BID Addendum No. Five (5)

PROJECT: Iona Preparatory School
Addition and Alterations to the
Pail Verni Fine Arts Center
255 Wilmot Road
New Rochelle, NY 10804

ADDENDUM NO. Five (5)
Initiation Date: June 24, 2021

Architect's Project No.: 1618
PGA Contact: Danny Lam
dlam@petergisolfiassociates.com
914-478-3677 x 340

Scale	Job No.	Date	Drawing No.
AS NOTED	1618	04/03/2019	A-151

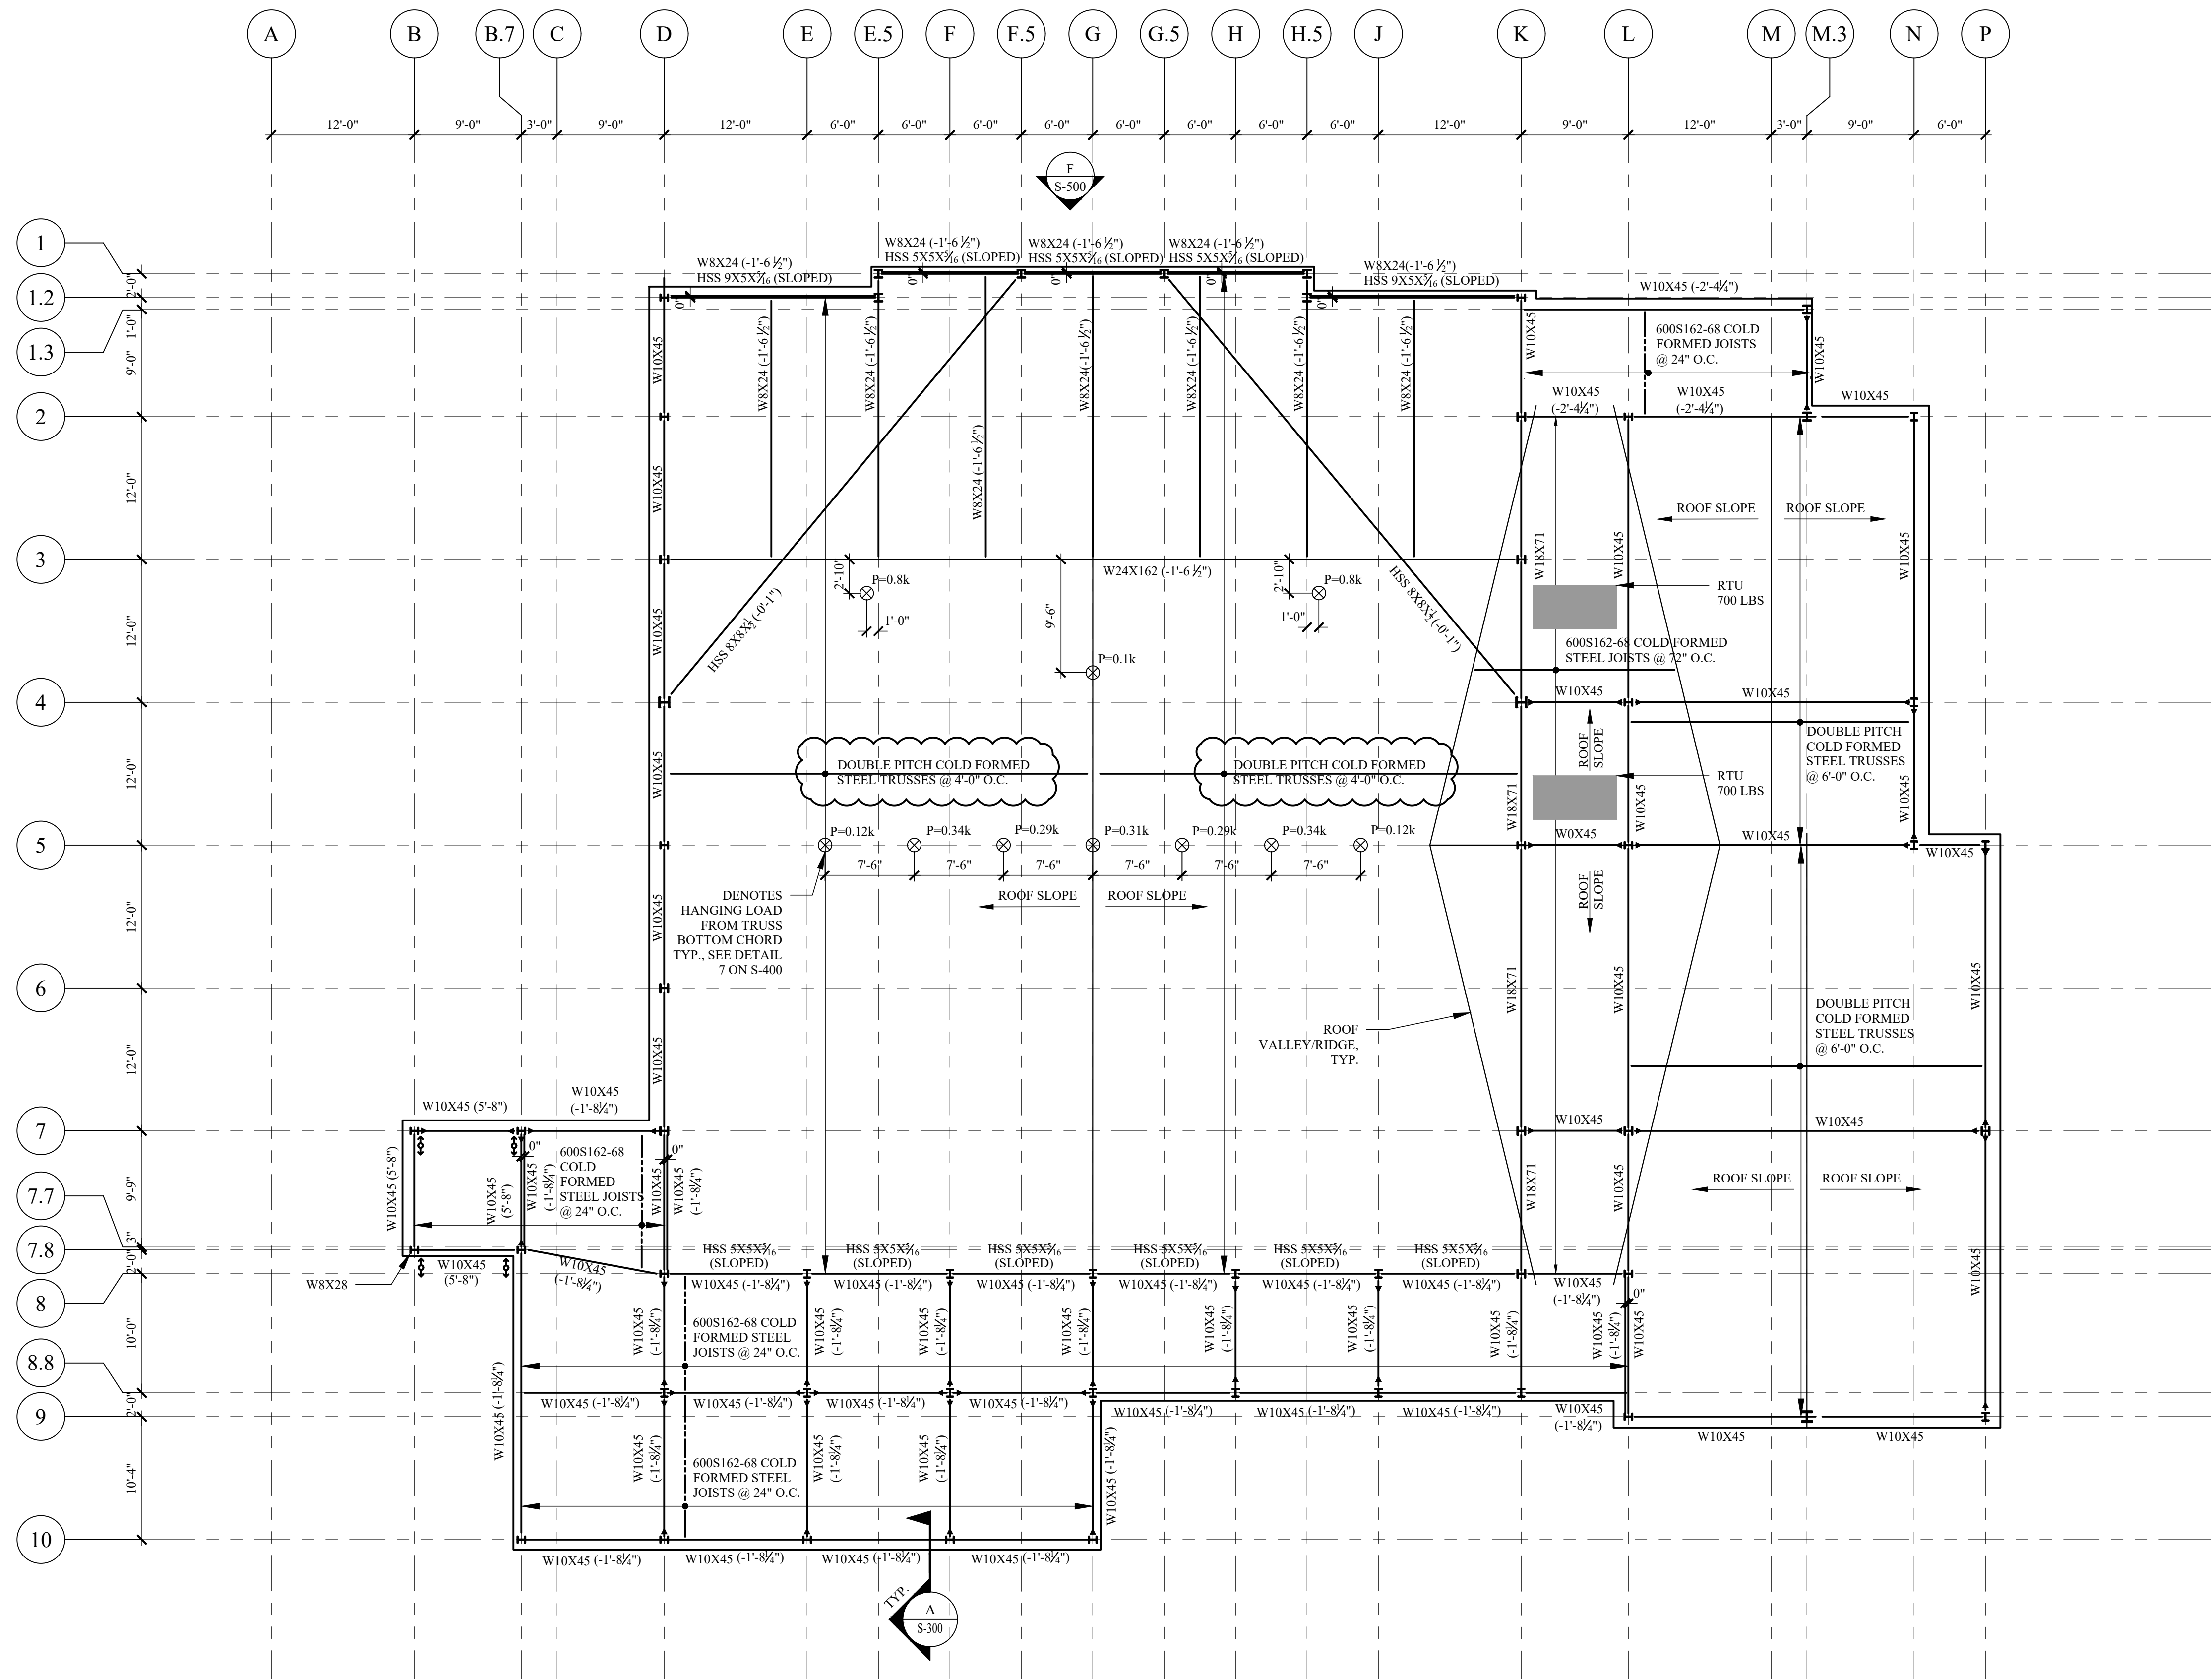
1. See attached revised sheets A-150 and A-151 with clarification to the 1st floor and 2nd floor lobby ceiling. Refer to A-950 Finish Schedule issued in addendum 1 for ceiling information.
2. Specification section 08 14 16 Flush Wood Doors – Paragraph 2.3(A)(5) note there are no sketch veneer doors for this project. Refer to door elevations on A-900.
3. All pilasters shown in the classrooms are painted gypsum board.
4. Specification section 10 11 00 Visual Display Surfaces – All markerboards/whiteboards shall be Claridge CONCEPT Dry Erase Board with aluminum trim and marker tray. All tackboards shall have wood trim per detail 1/A-600.

Scale	Job No.	Date	Drawing No.
1/8"=1'-0"	20-2723	04/03/2019	M-201

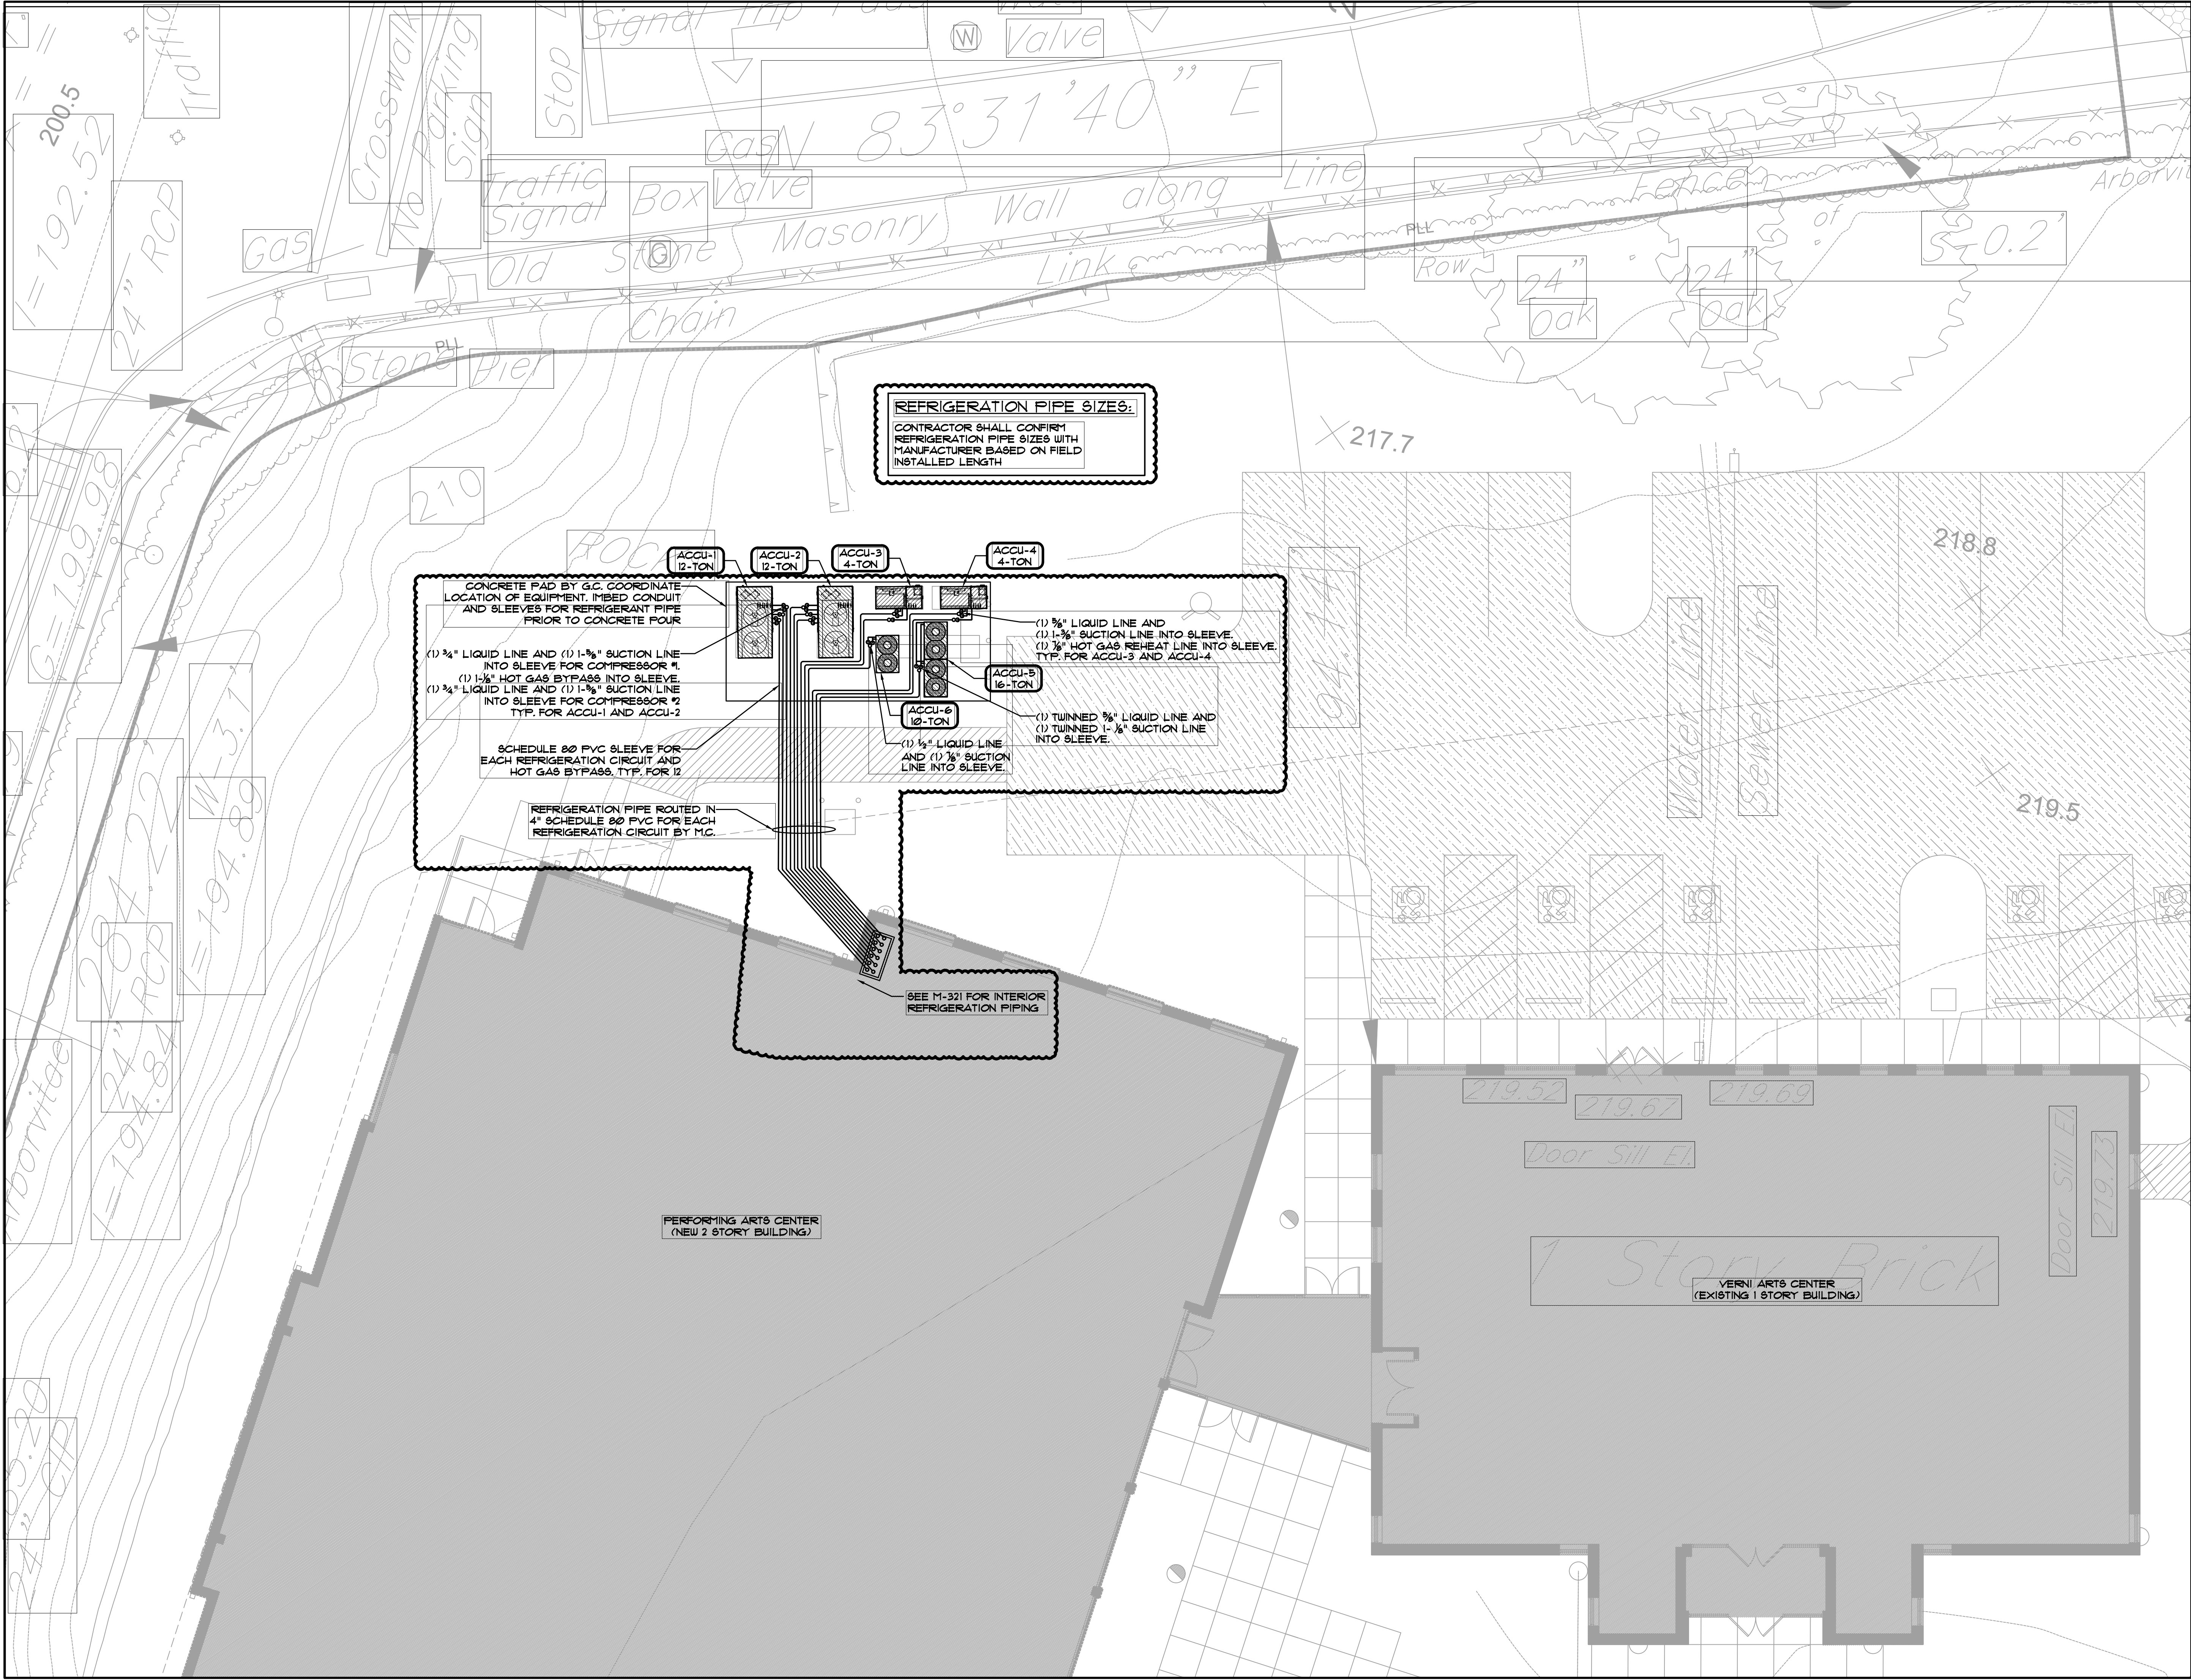
4. See attached revised sheet M-201 with revisions to Verni demolition.
5. See attached revised sheet M-301 with revisions to mechanical construction plan.

Drawing Title
MECHANICAL SITE PLAN

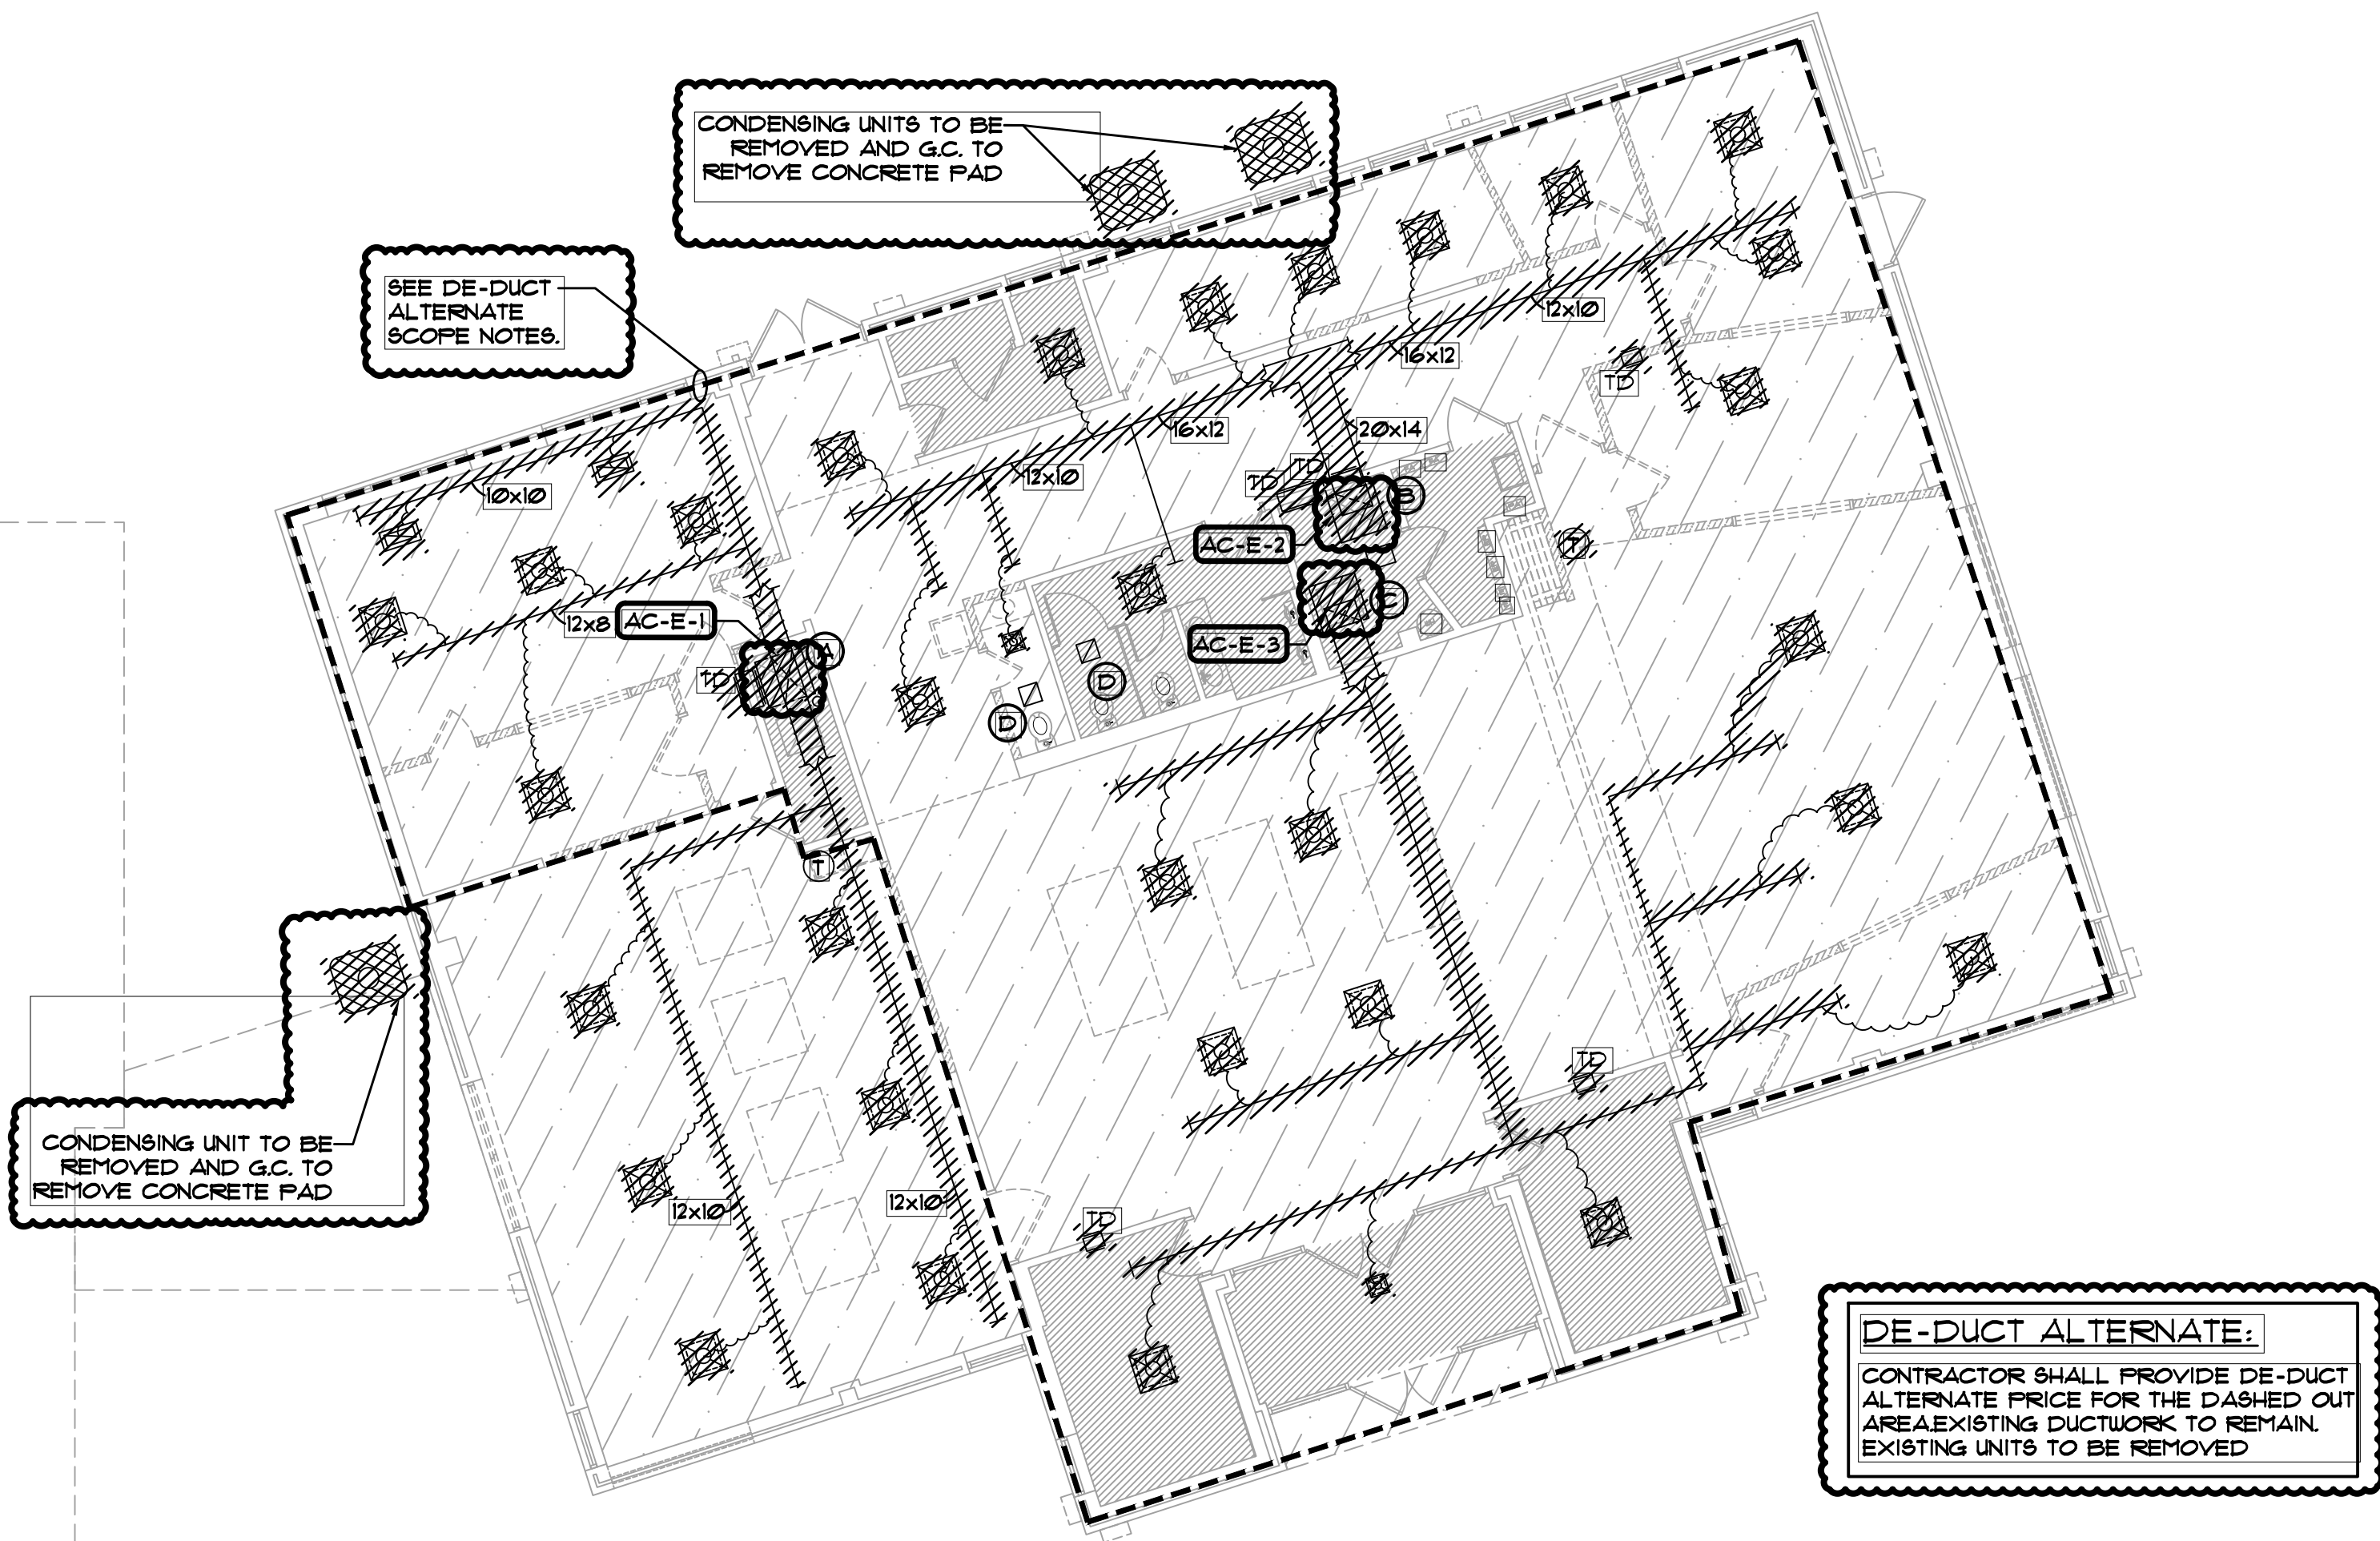
1. See attached revised sheet M-101 with revisions to HVAC notes.
2. See attached revised sheet M-102 with revisions to HVAC symbols.
3. See attached revised sheet M-103 with revisions to mechanical site plan.
